To: Cranston City Plan Commission
From: Joshua Berry, AICP, Senior Planner
Date: January 4, 2021
Re: Variance Application for 900 Cranston Street Crossroad (AP 7, Lot 295, 299 & 300)

Owner: ADJ Realty Co.
Applicant: F & C Donuts (DBA Dunkin' Donuts)
Location: 900 Cranston Street
Zone: C-5 (Heavy Business, Industry)
FLU: Highway Commercial/Services

1. To allow a new animated sign (digital message board) to replace the changeable copy sign portion on an existing free standing sign where LED/digital/animated signs are not allowed in any zone. [17.72.010 - Signs]

EXISTING VS PROPOSED

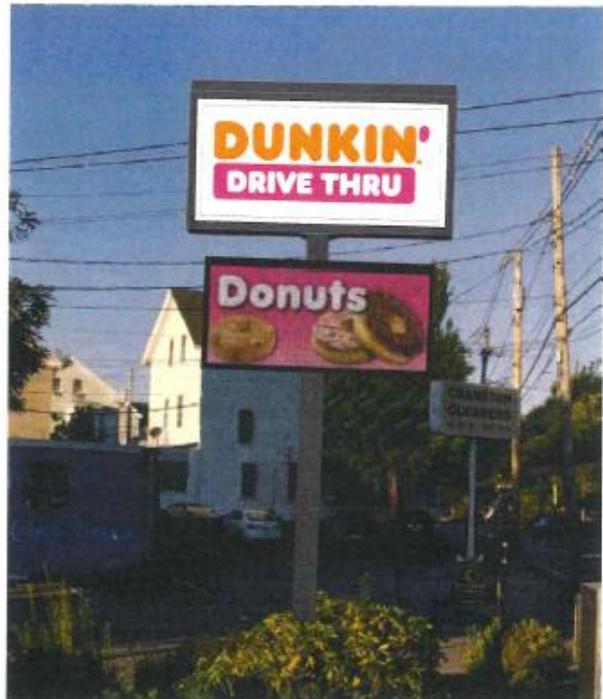
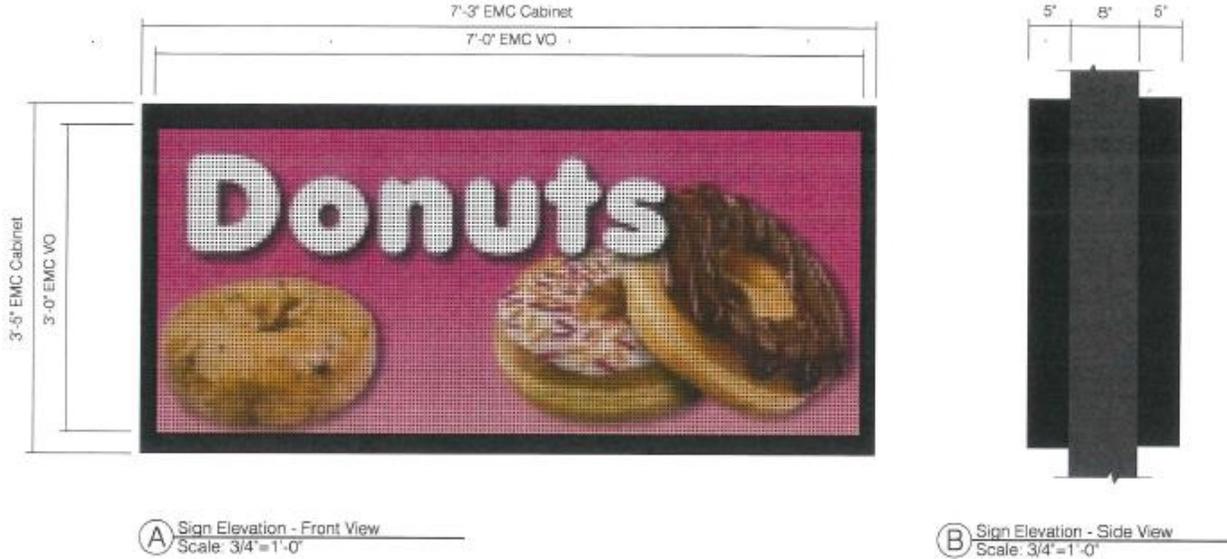
1. The applicant, F & C Donuts (DBA Dunkin' Donuts) has requested a sign variance to replace an existing message board (6' x 6' or 36 ft² per side) with a digital LED message board (animated sign) of lesser area (7' x 3' or 21ft² per side). The sign would be located under the existing portion of the free standing sign for Dunkin' Donuts (4'- 8.5" x 8' - 4.5" or 25.5 ft² per side). The total area (93 ft²) exceeds the 50 ft² maximum per C-5 zoning. In addition, electronic LED message board signs are considered "animated signs" and are not permitted in the Zoning Code in any zone. Per Zoning Sect 17.72.010.G. [Signs Prohibited Under This Section]: *"All signs not expressly permitted under this section or exempt from regulation hereunder in accordance with the previous section are prohibited in the city."*

The application seeks to replace the existing 6' x 6' changeable copy portion of the free standing sign with a new electronic LED message board (animated sign) at 900 Cranston St. The existing free standing sign was approved by the Cranston Zoning Board of Review (ZBR) in December of 2000, except that it appears that other tenants were anticipated to occupy the site, which never matriculated. The other tenants were each allotted a 2' x 6' sign under the anchor tenants free standing sign. Instead, these signs were combined and the existing changeable copy sign was permitted for the single tenant, Dunkin' Donuts. The applicant's proposed animated sign would be 15 ft² smaller per side than the changeable copy sign, proposing 21 ft² per side.
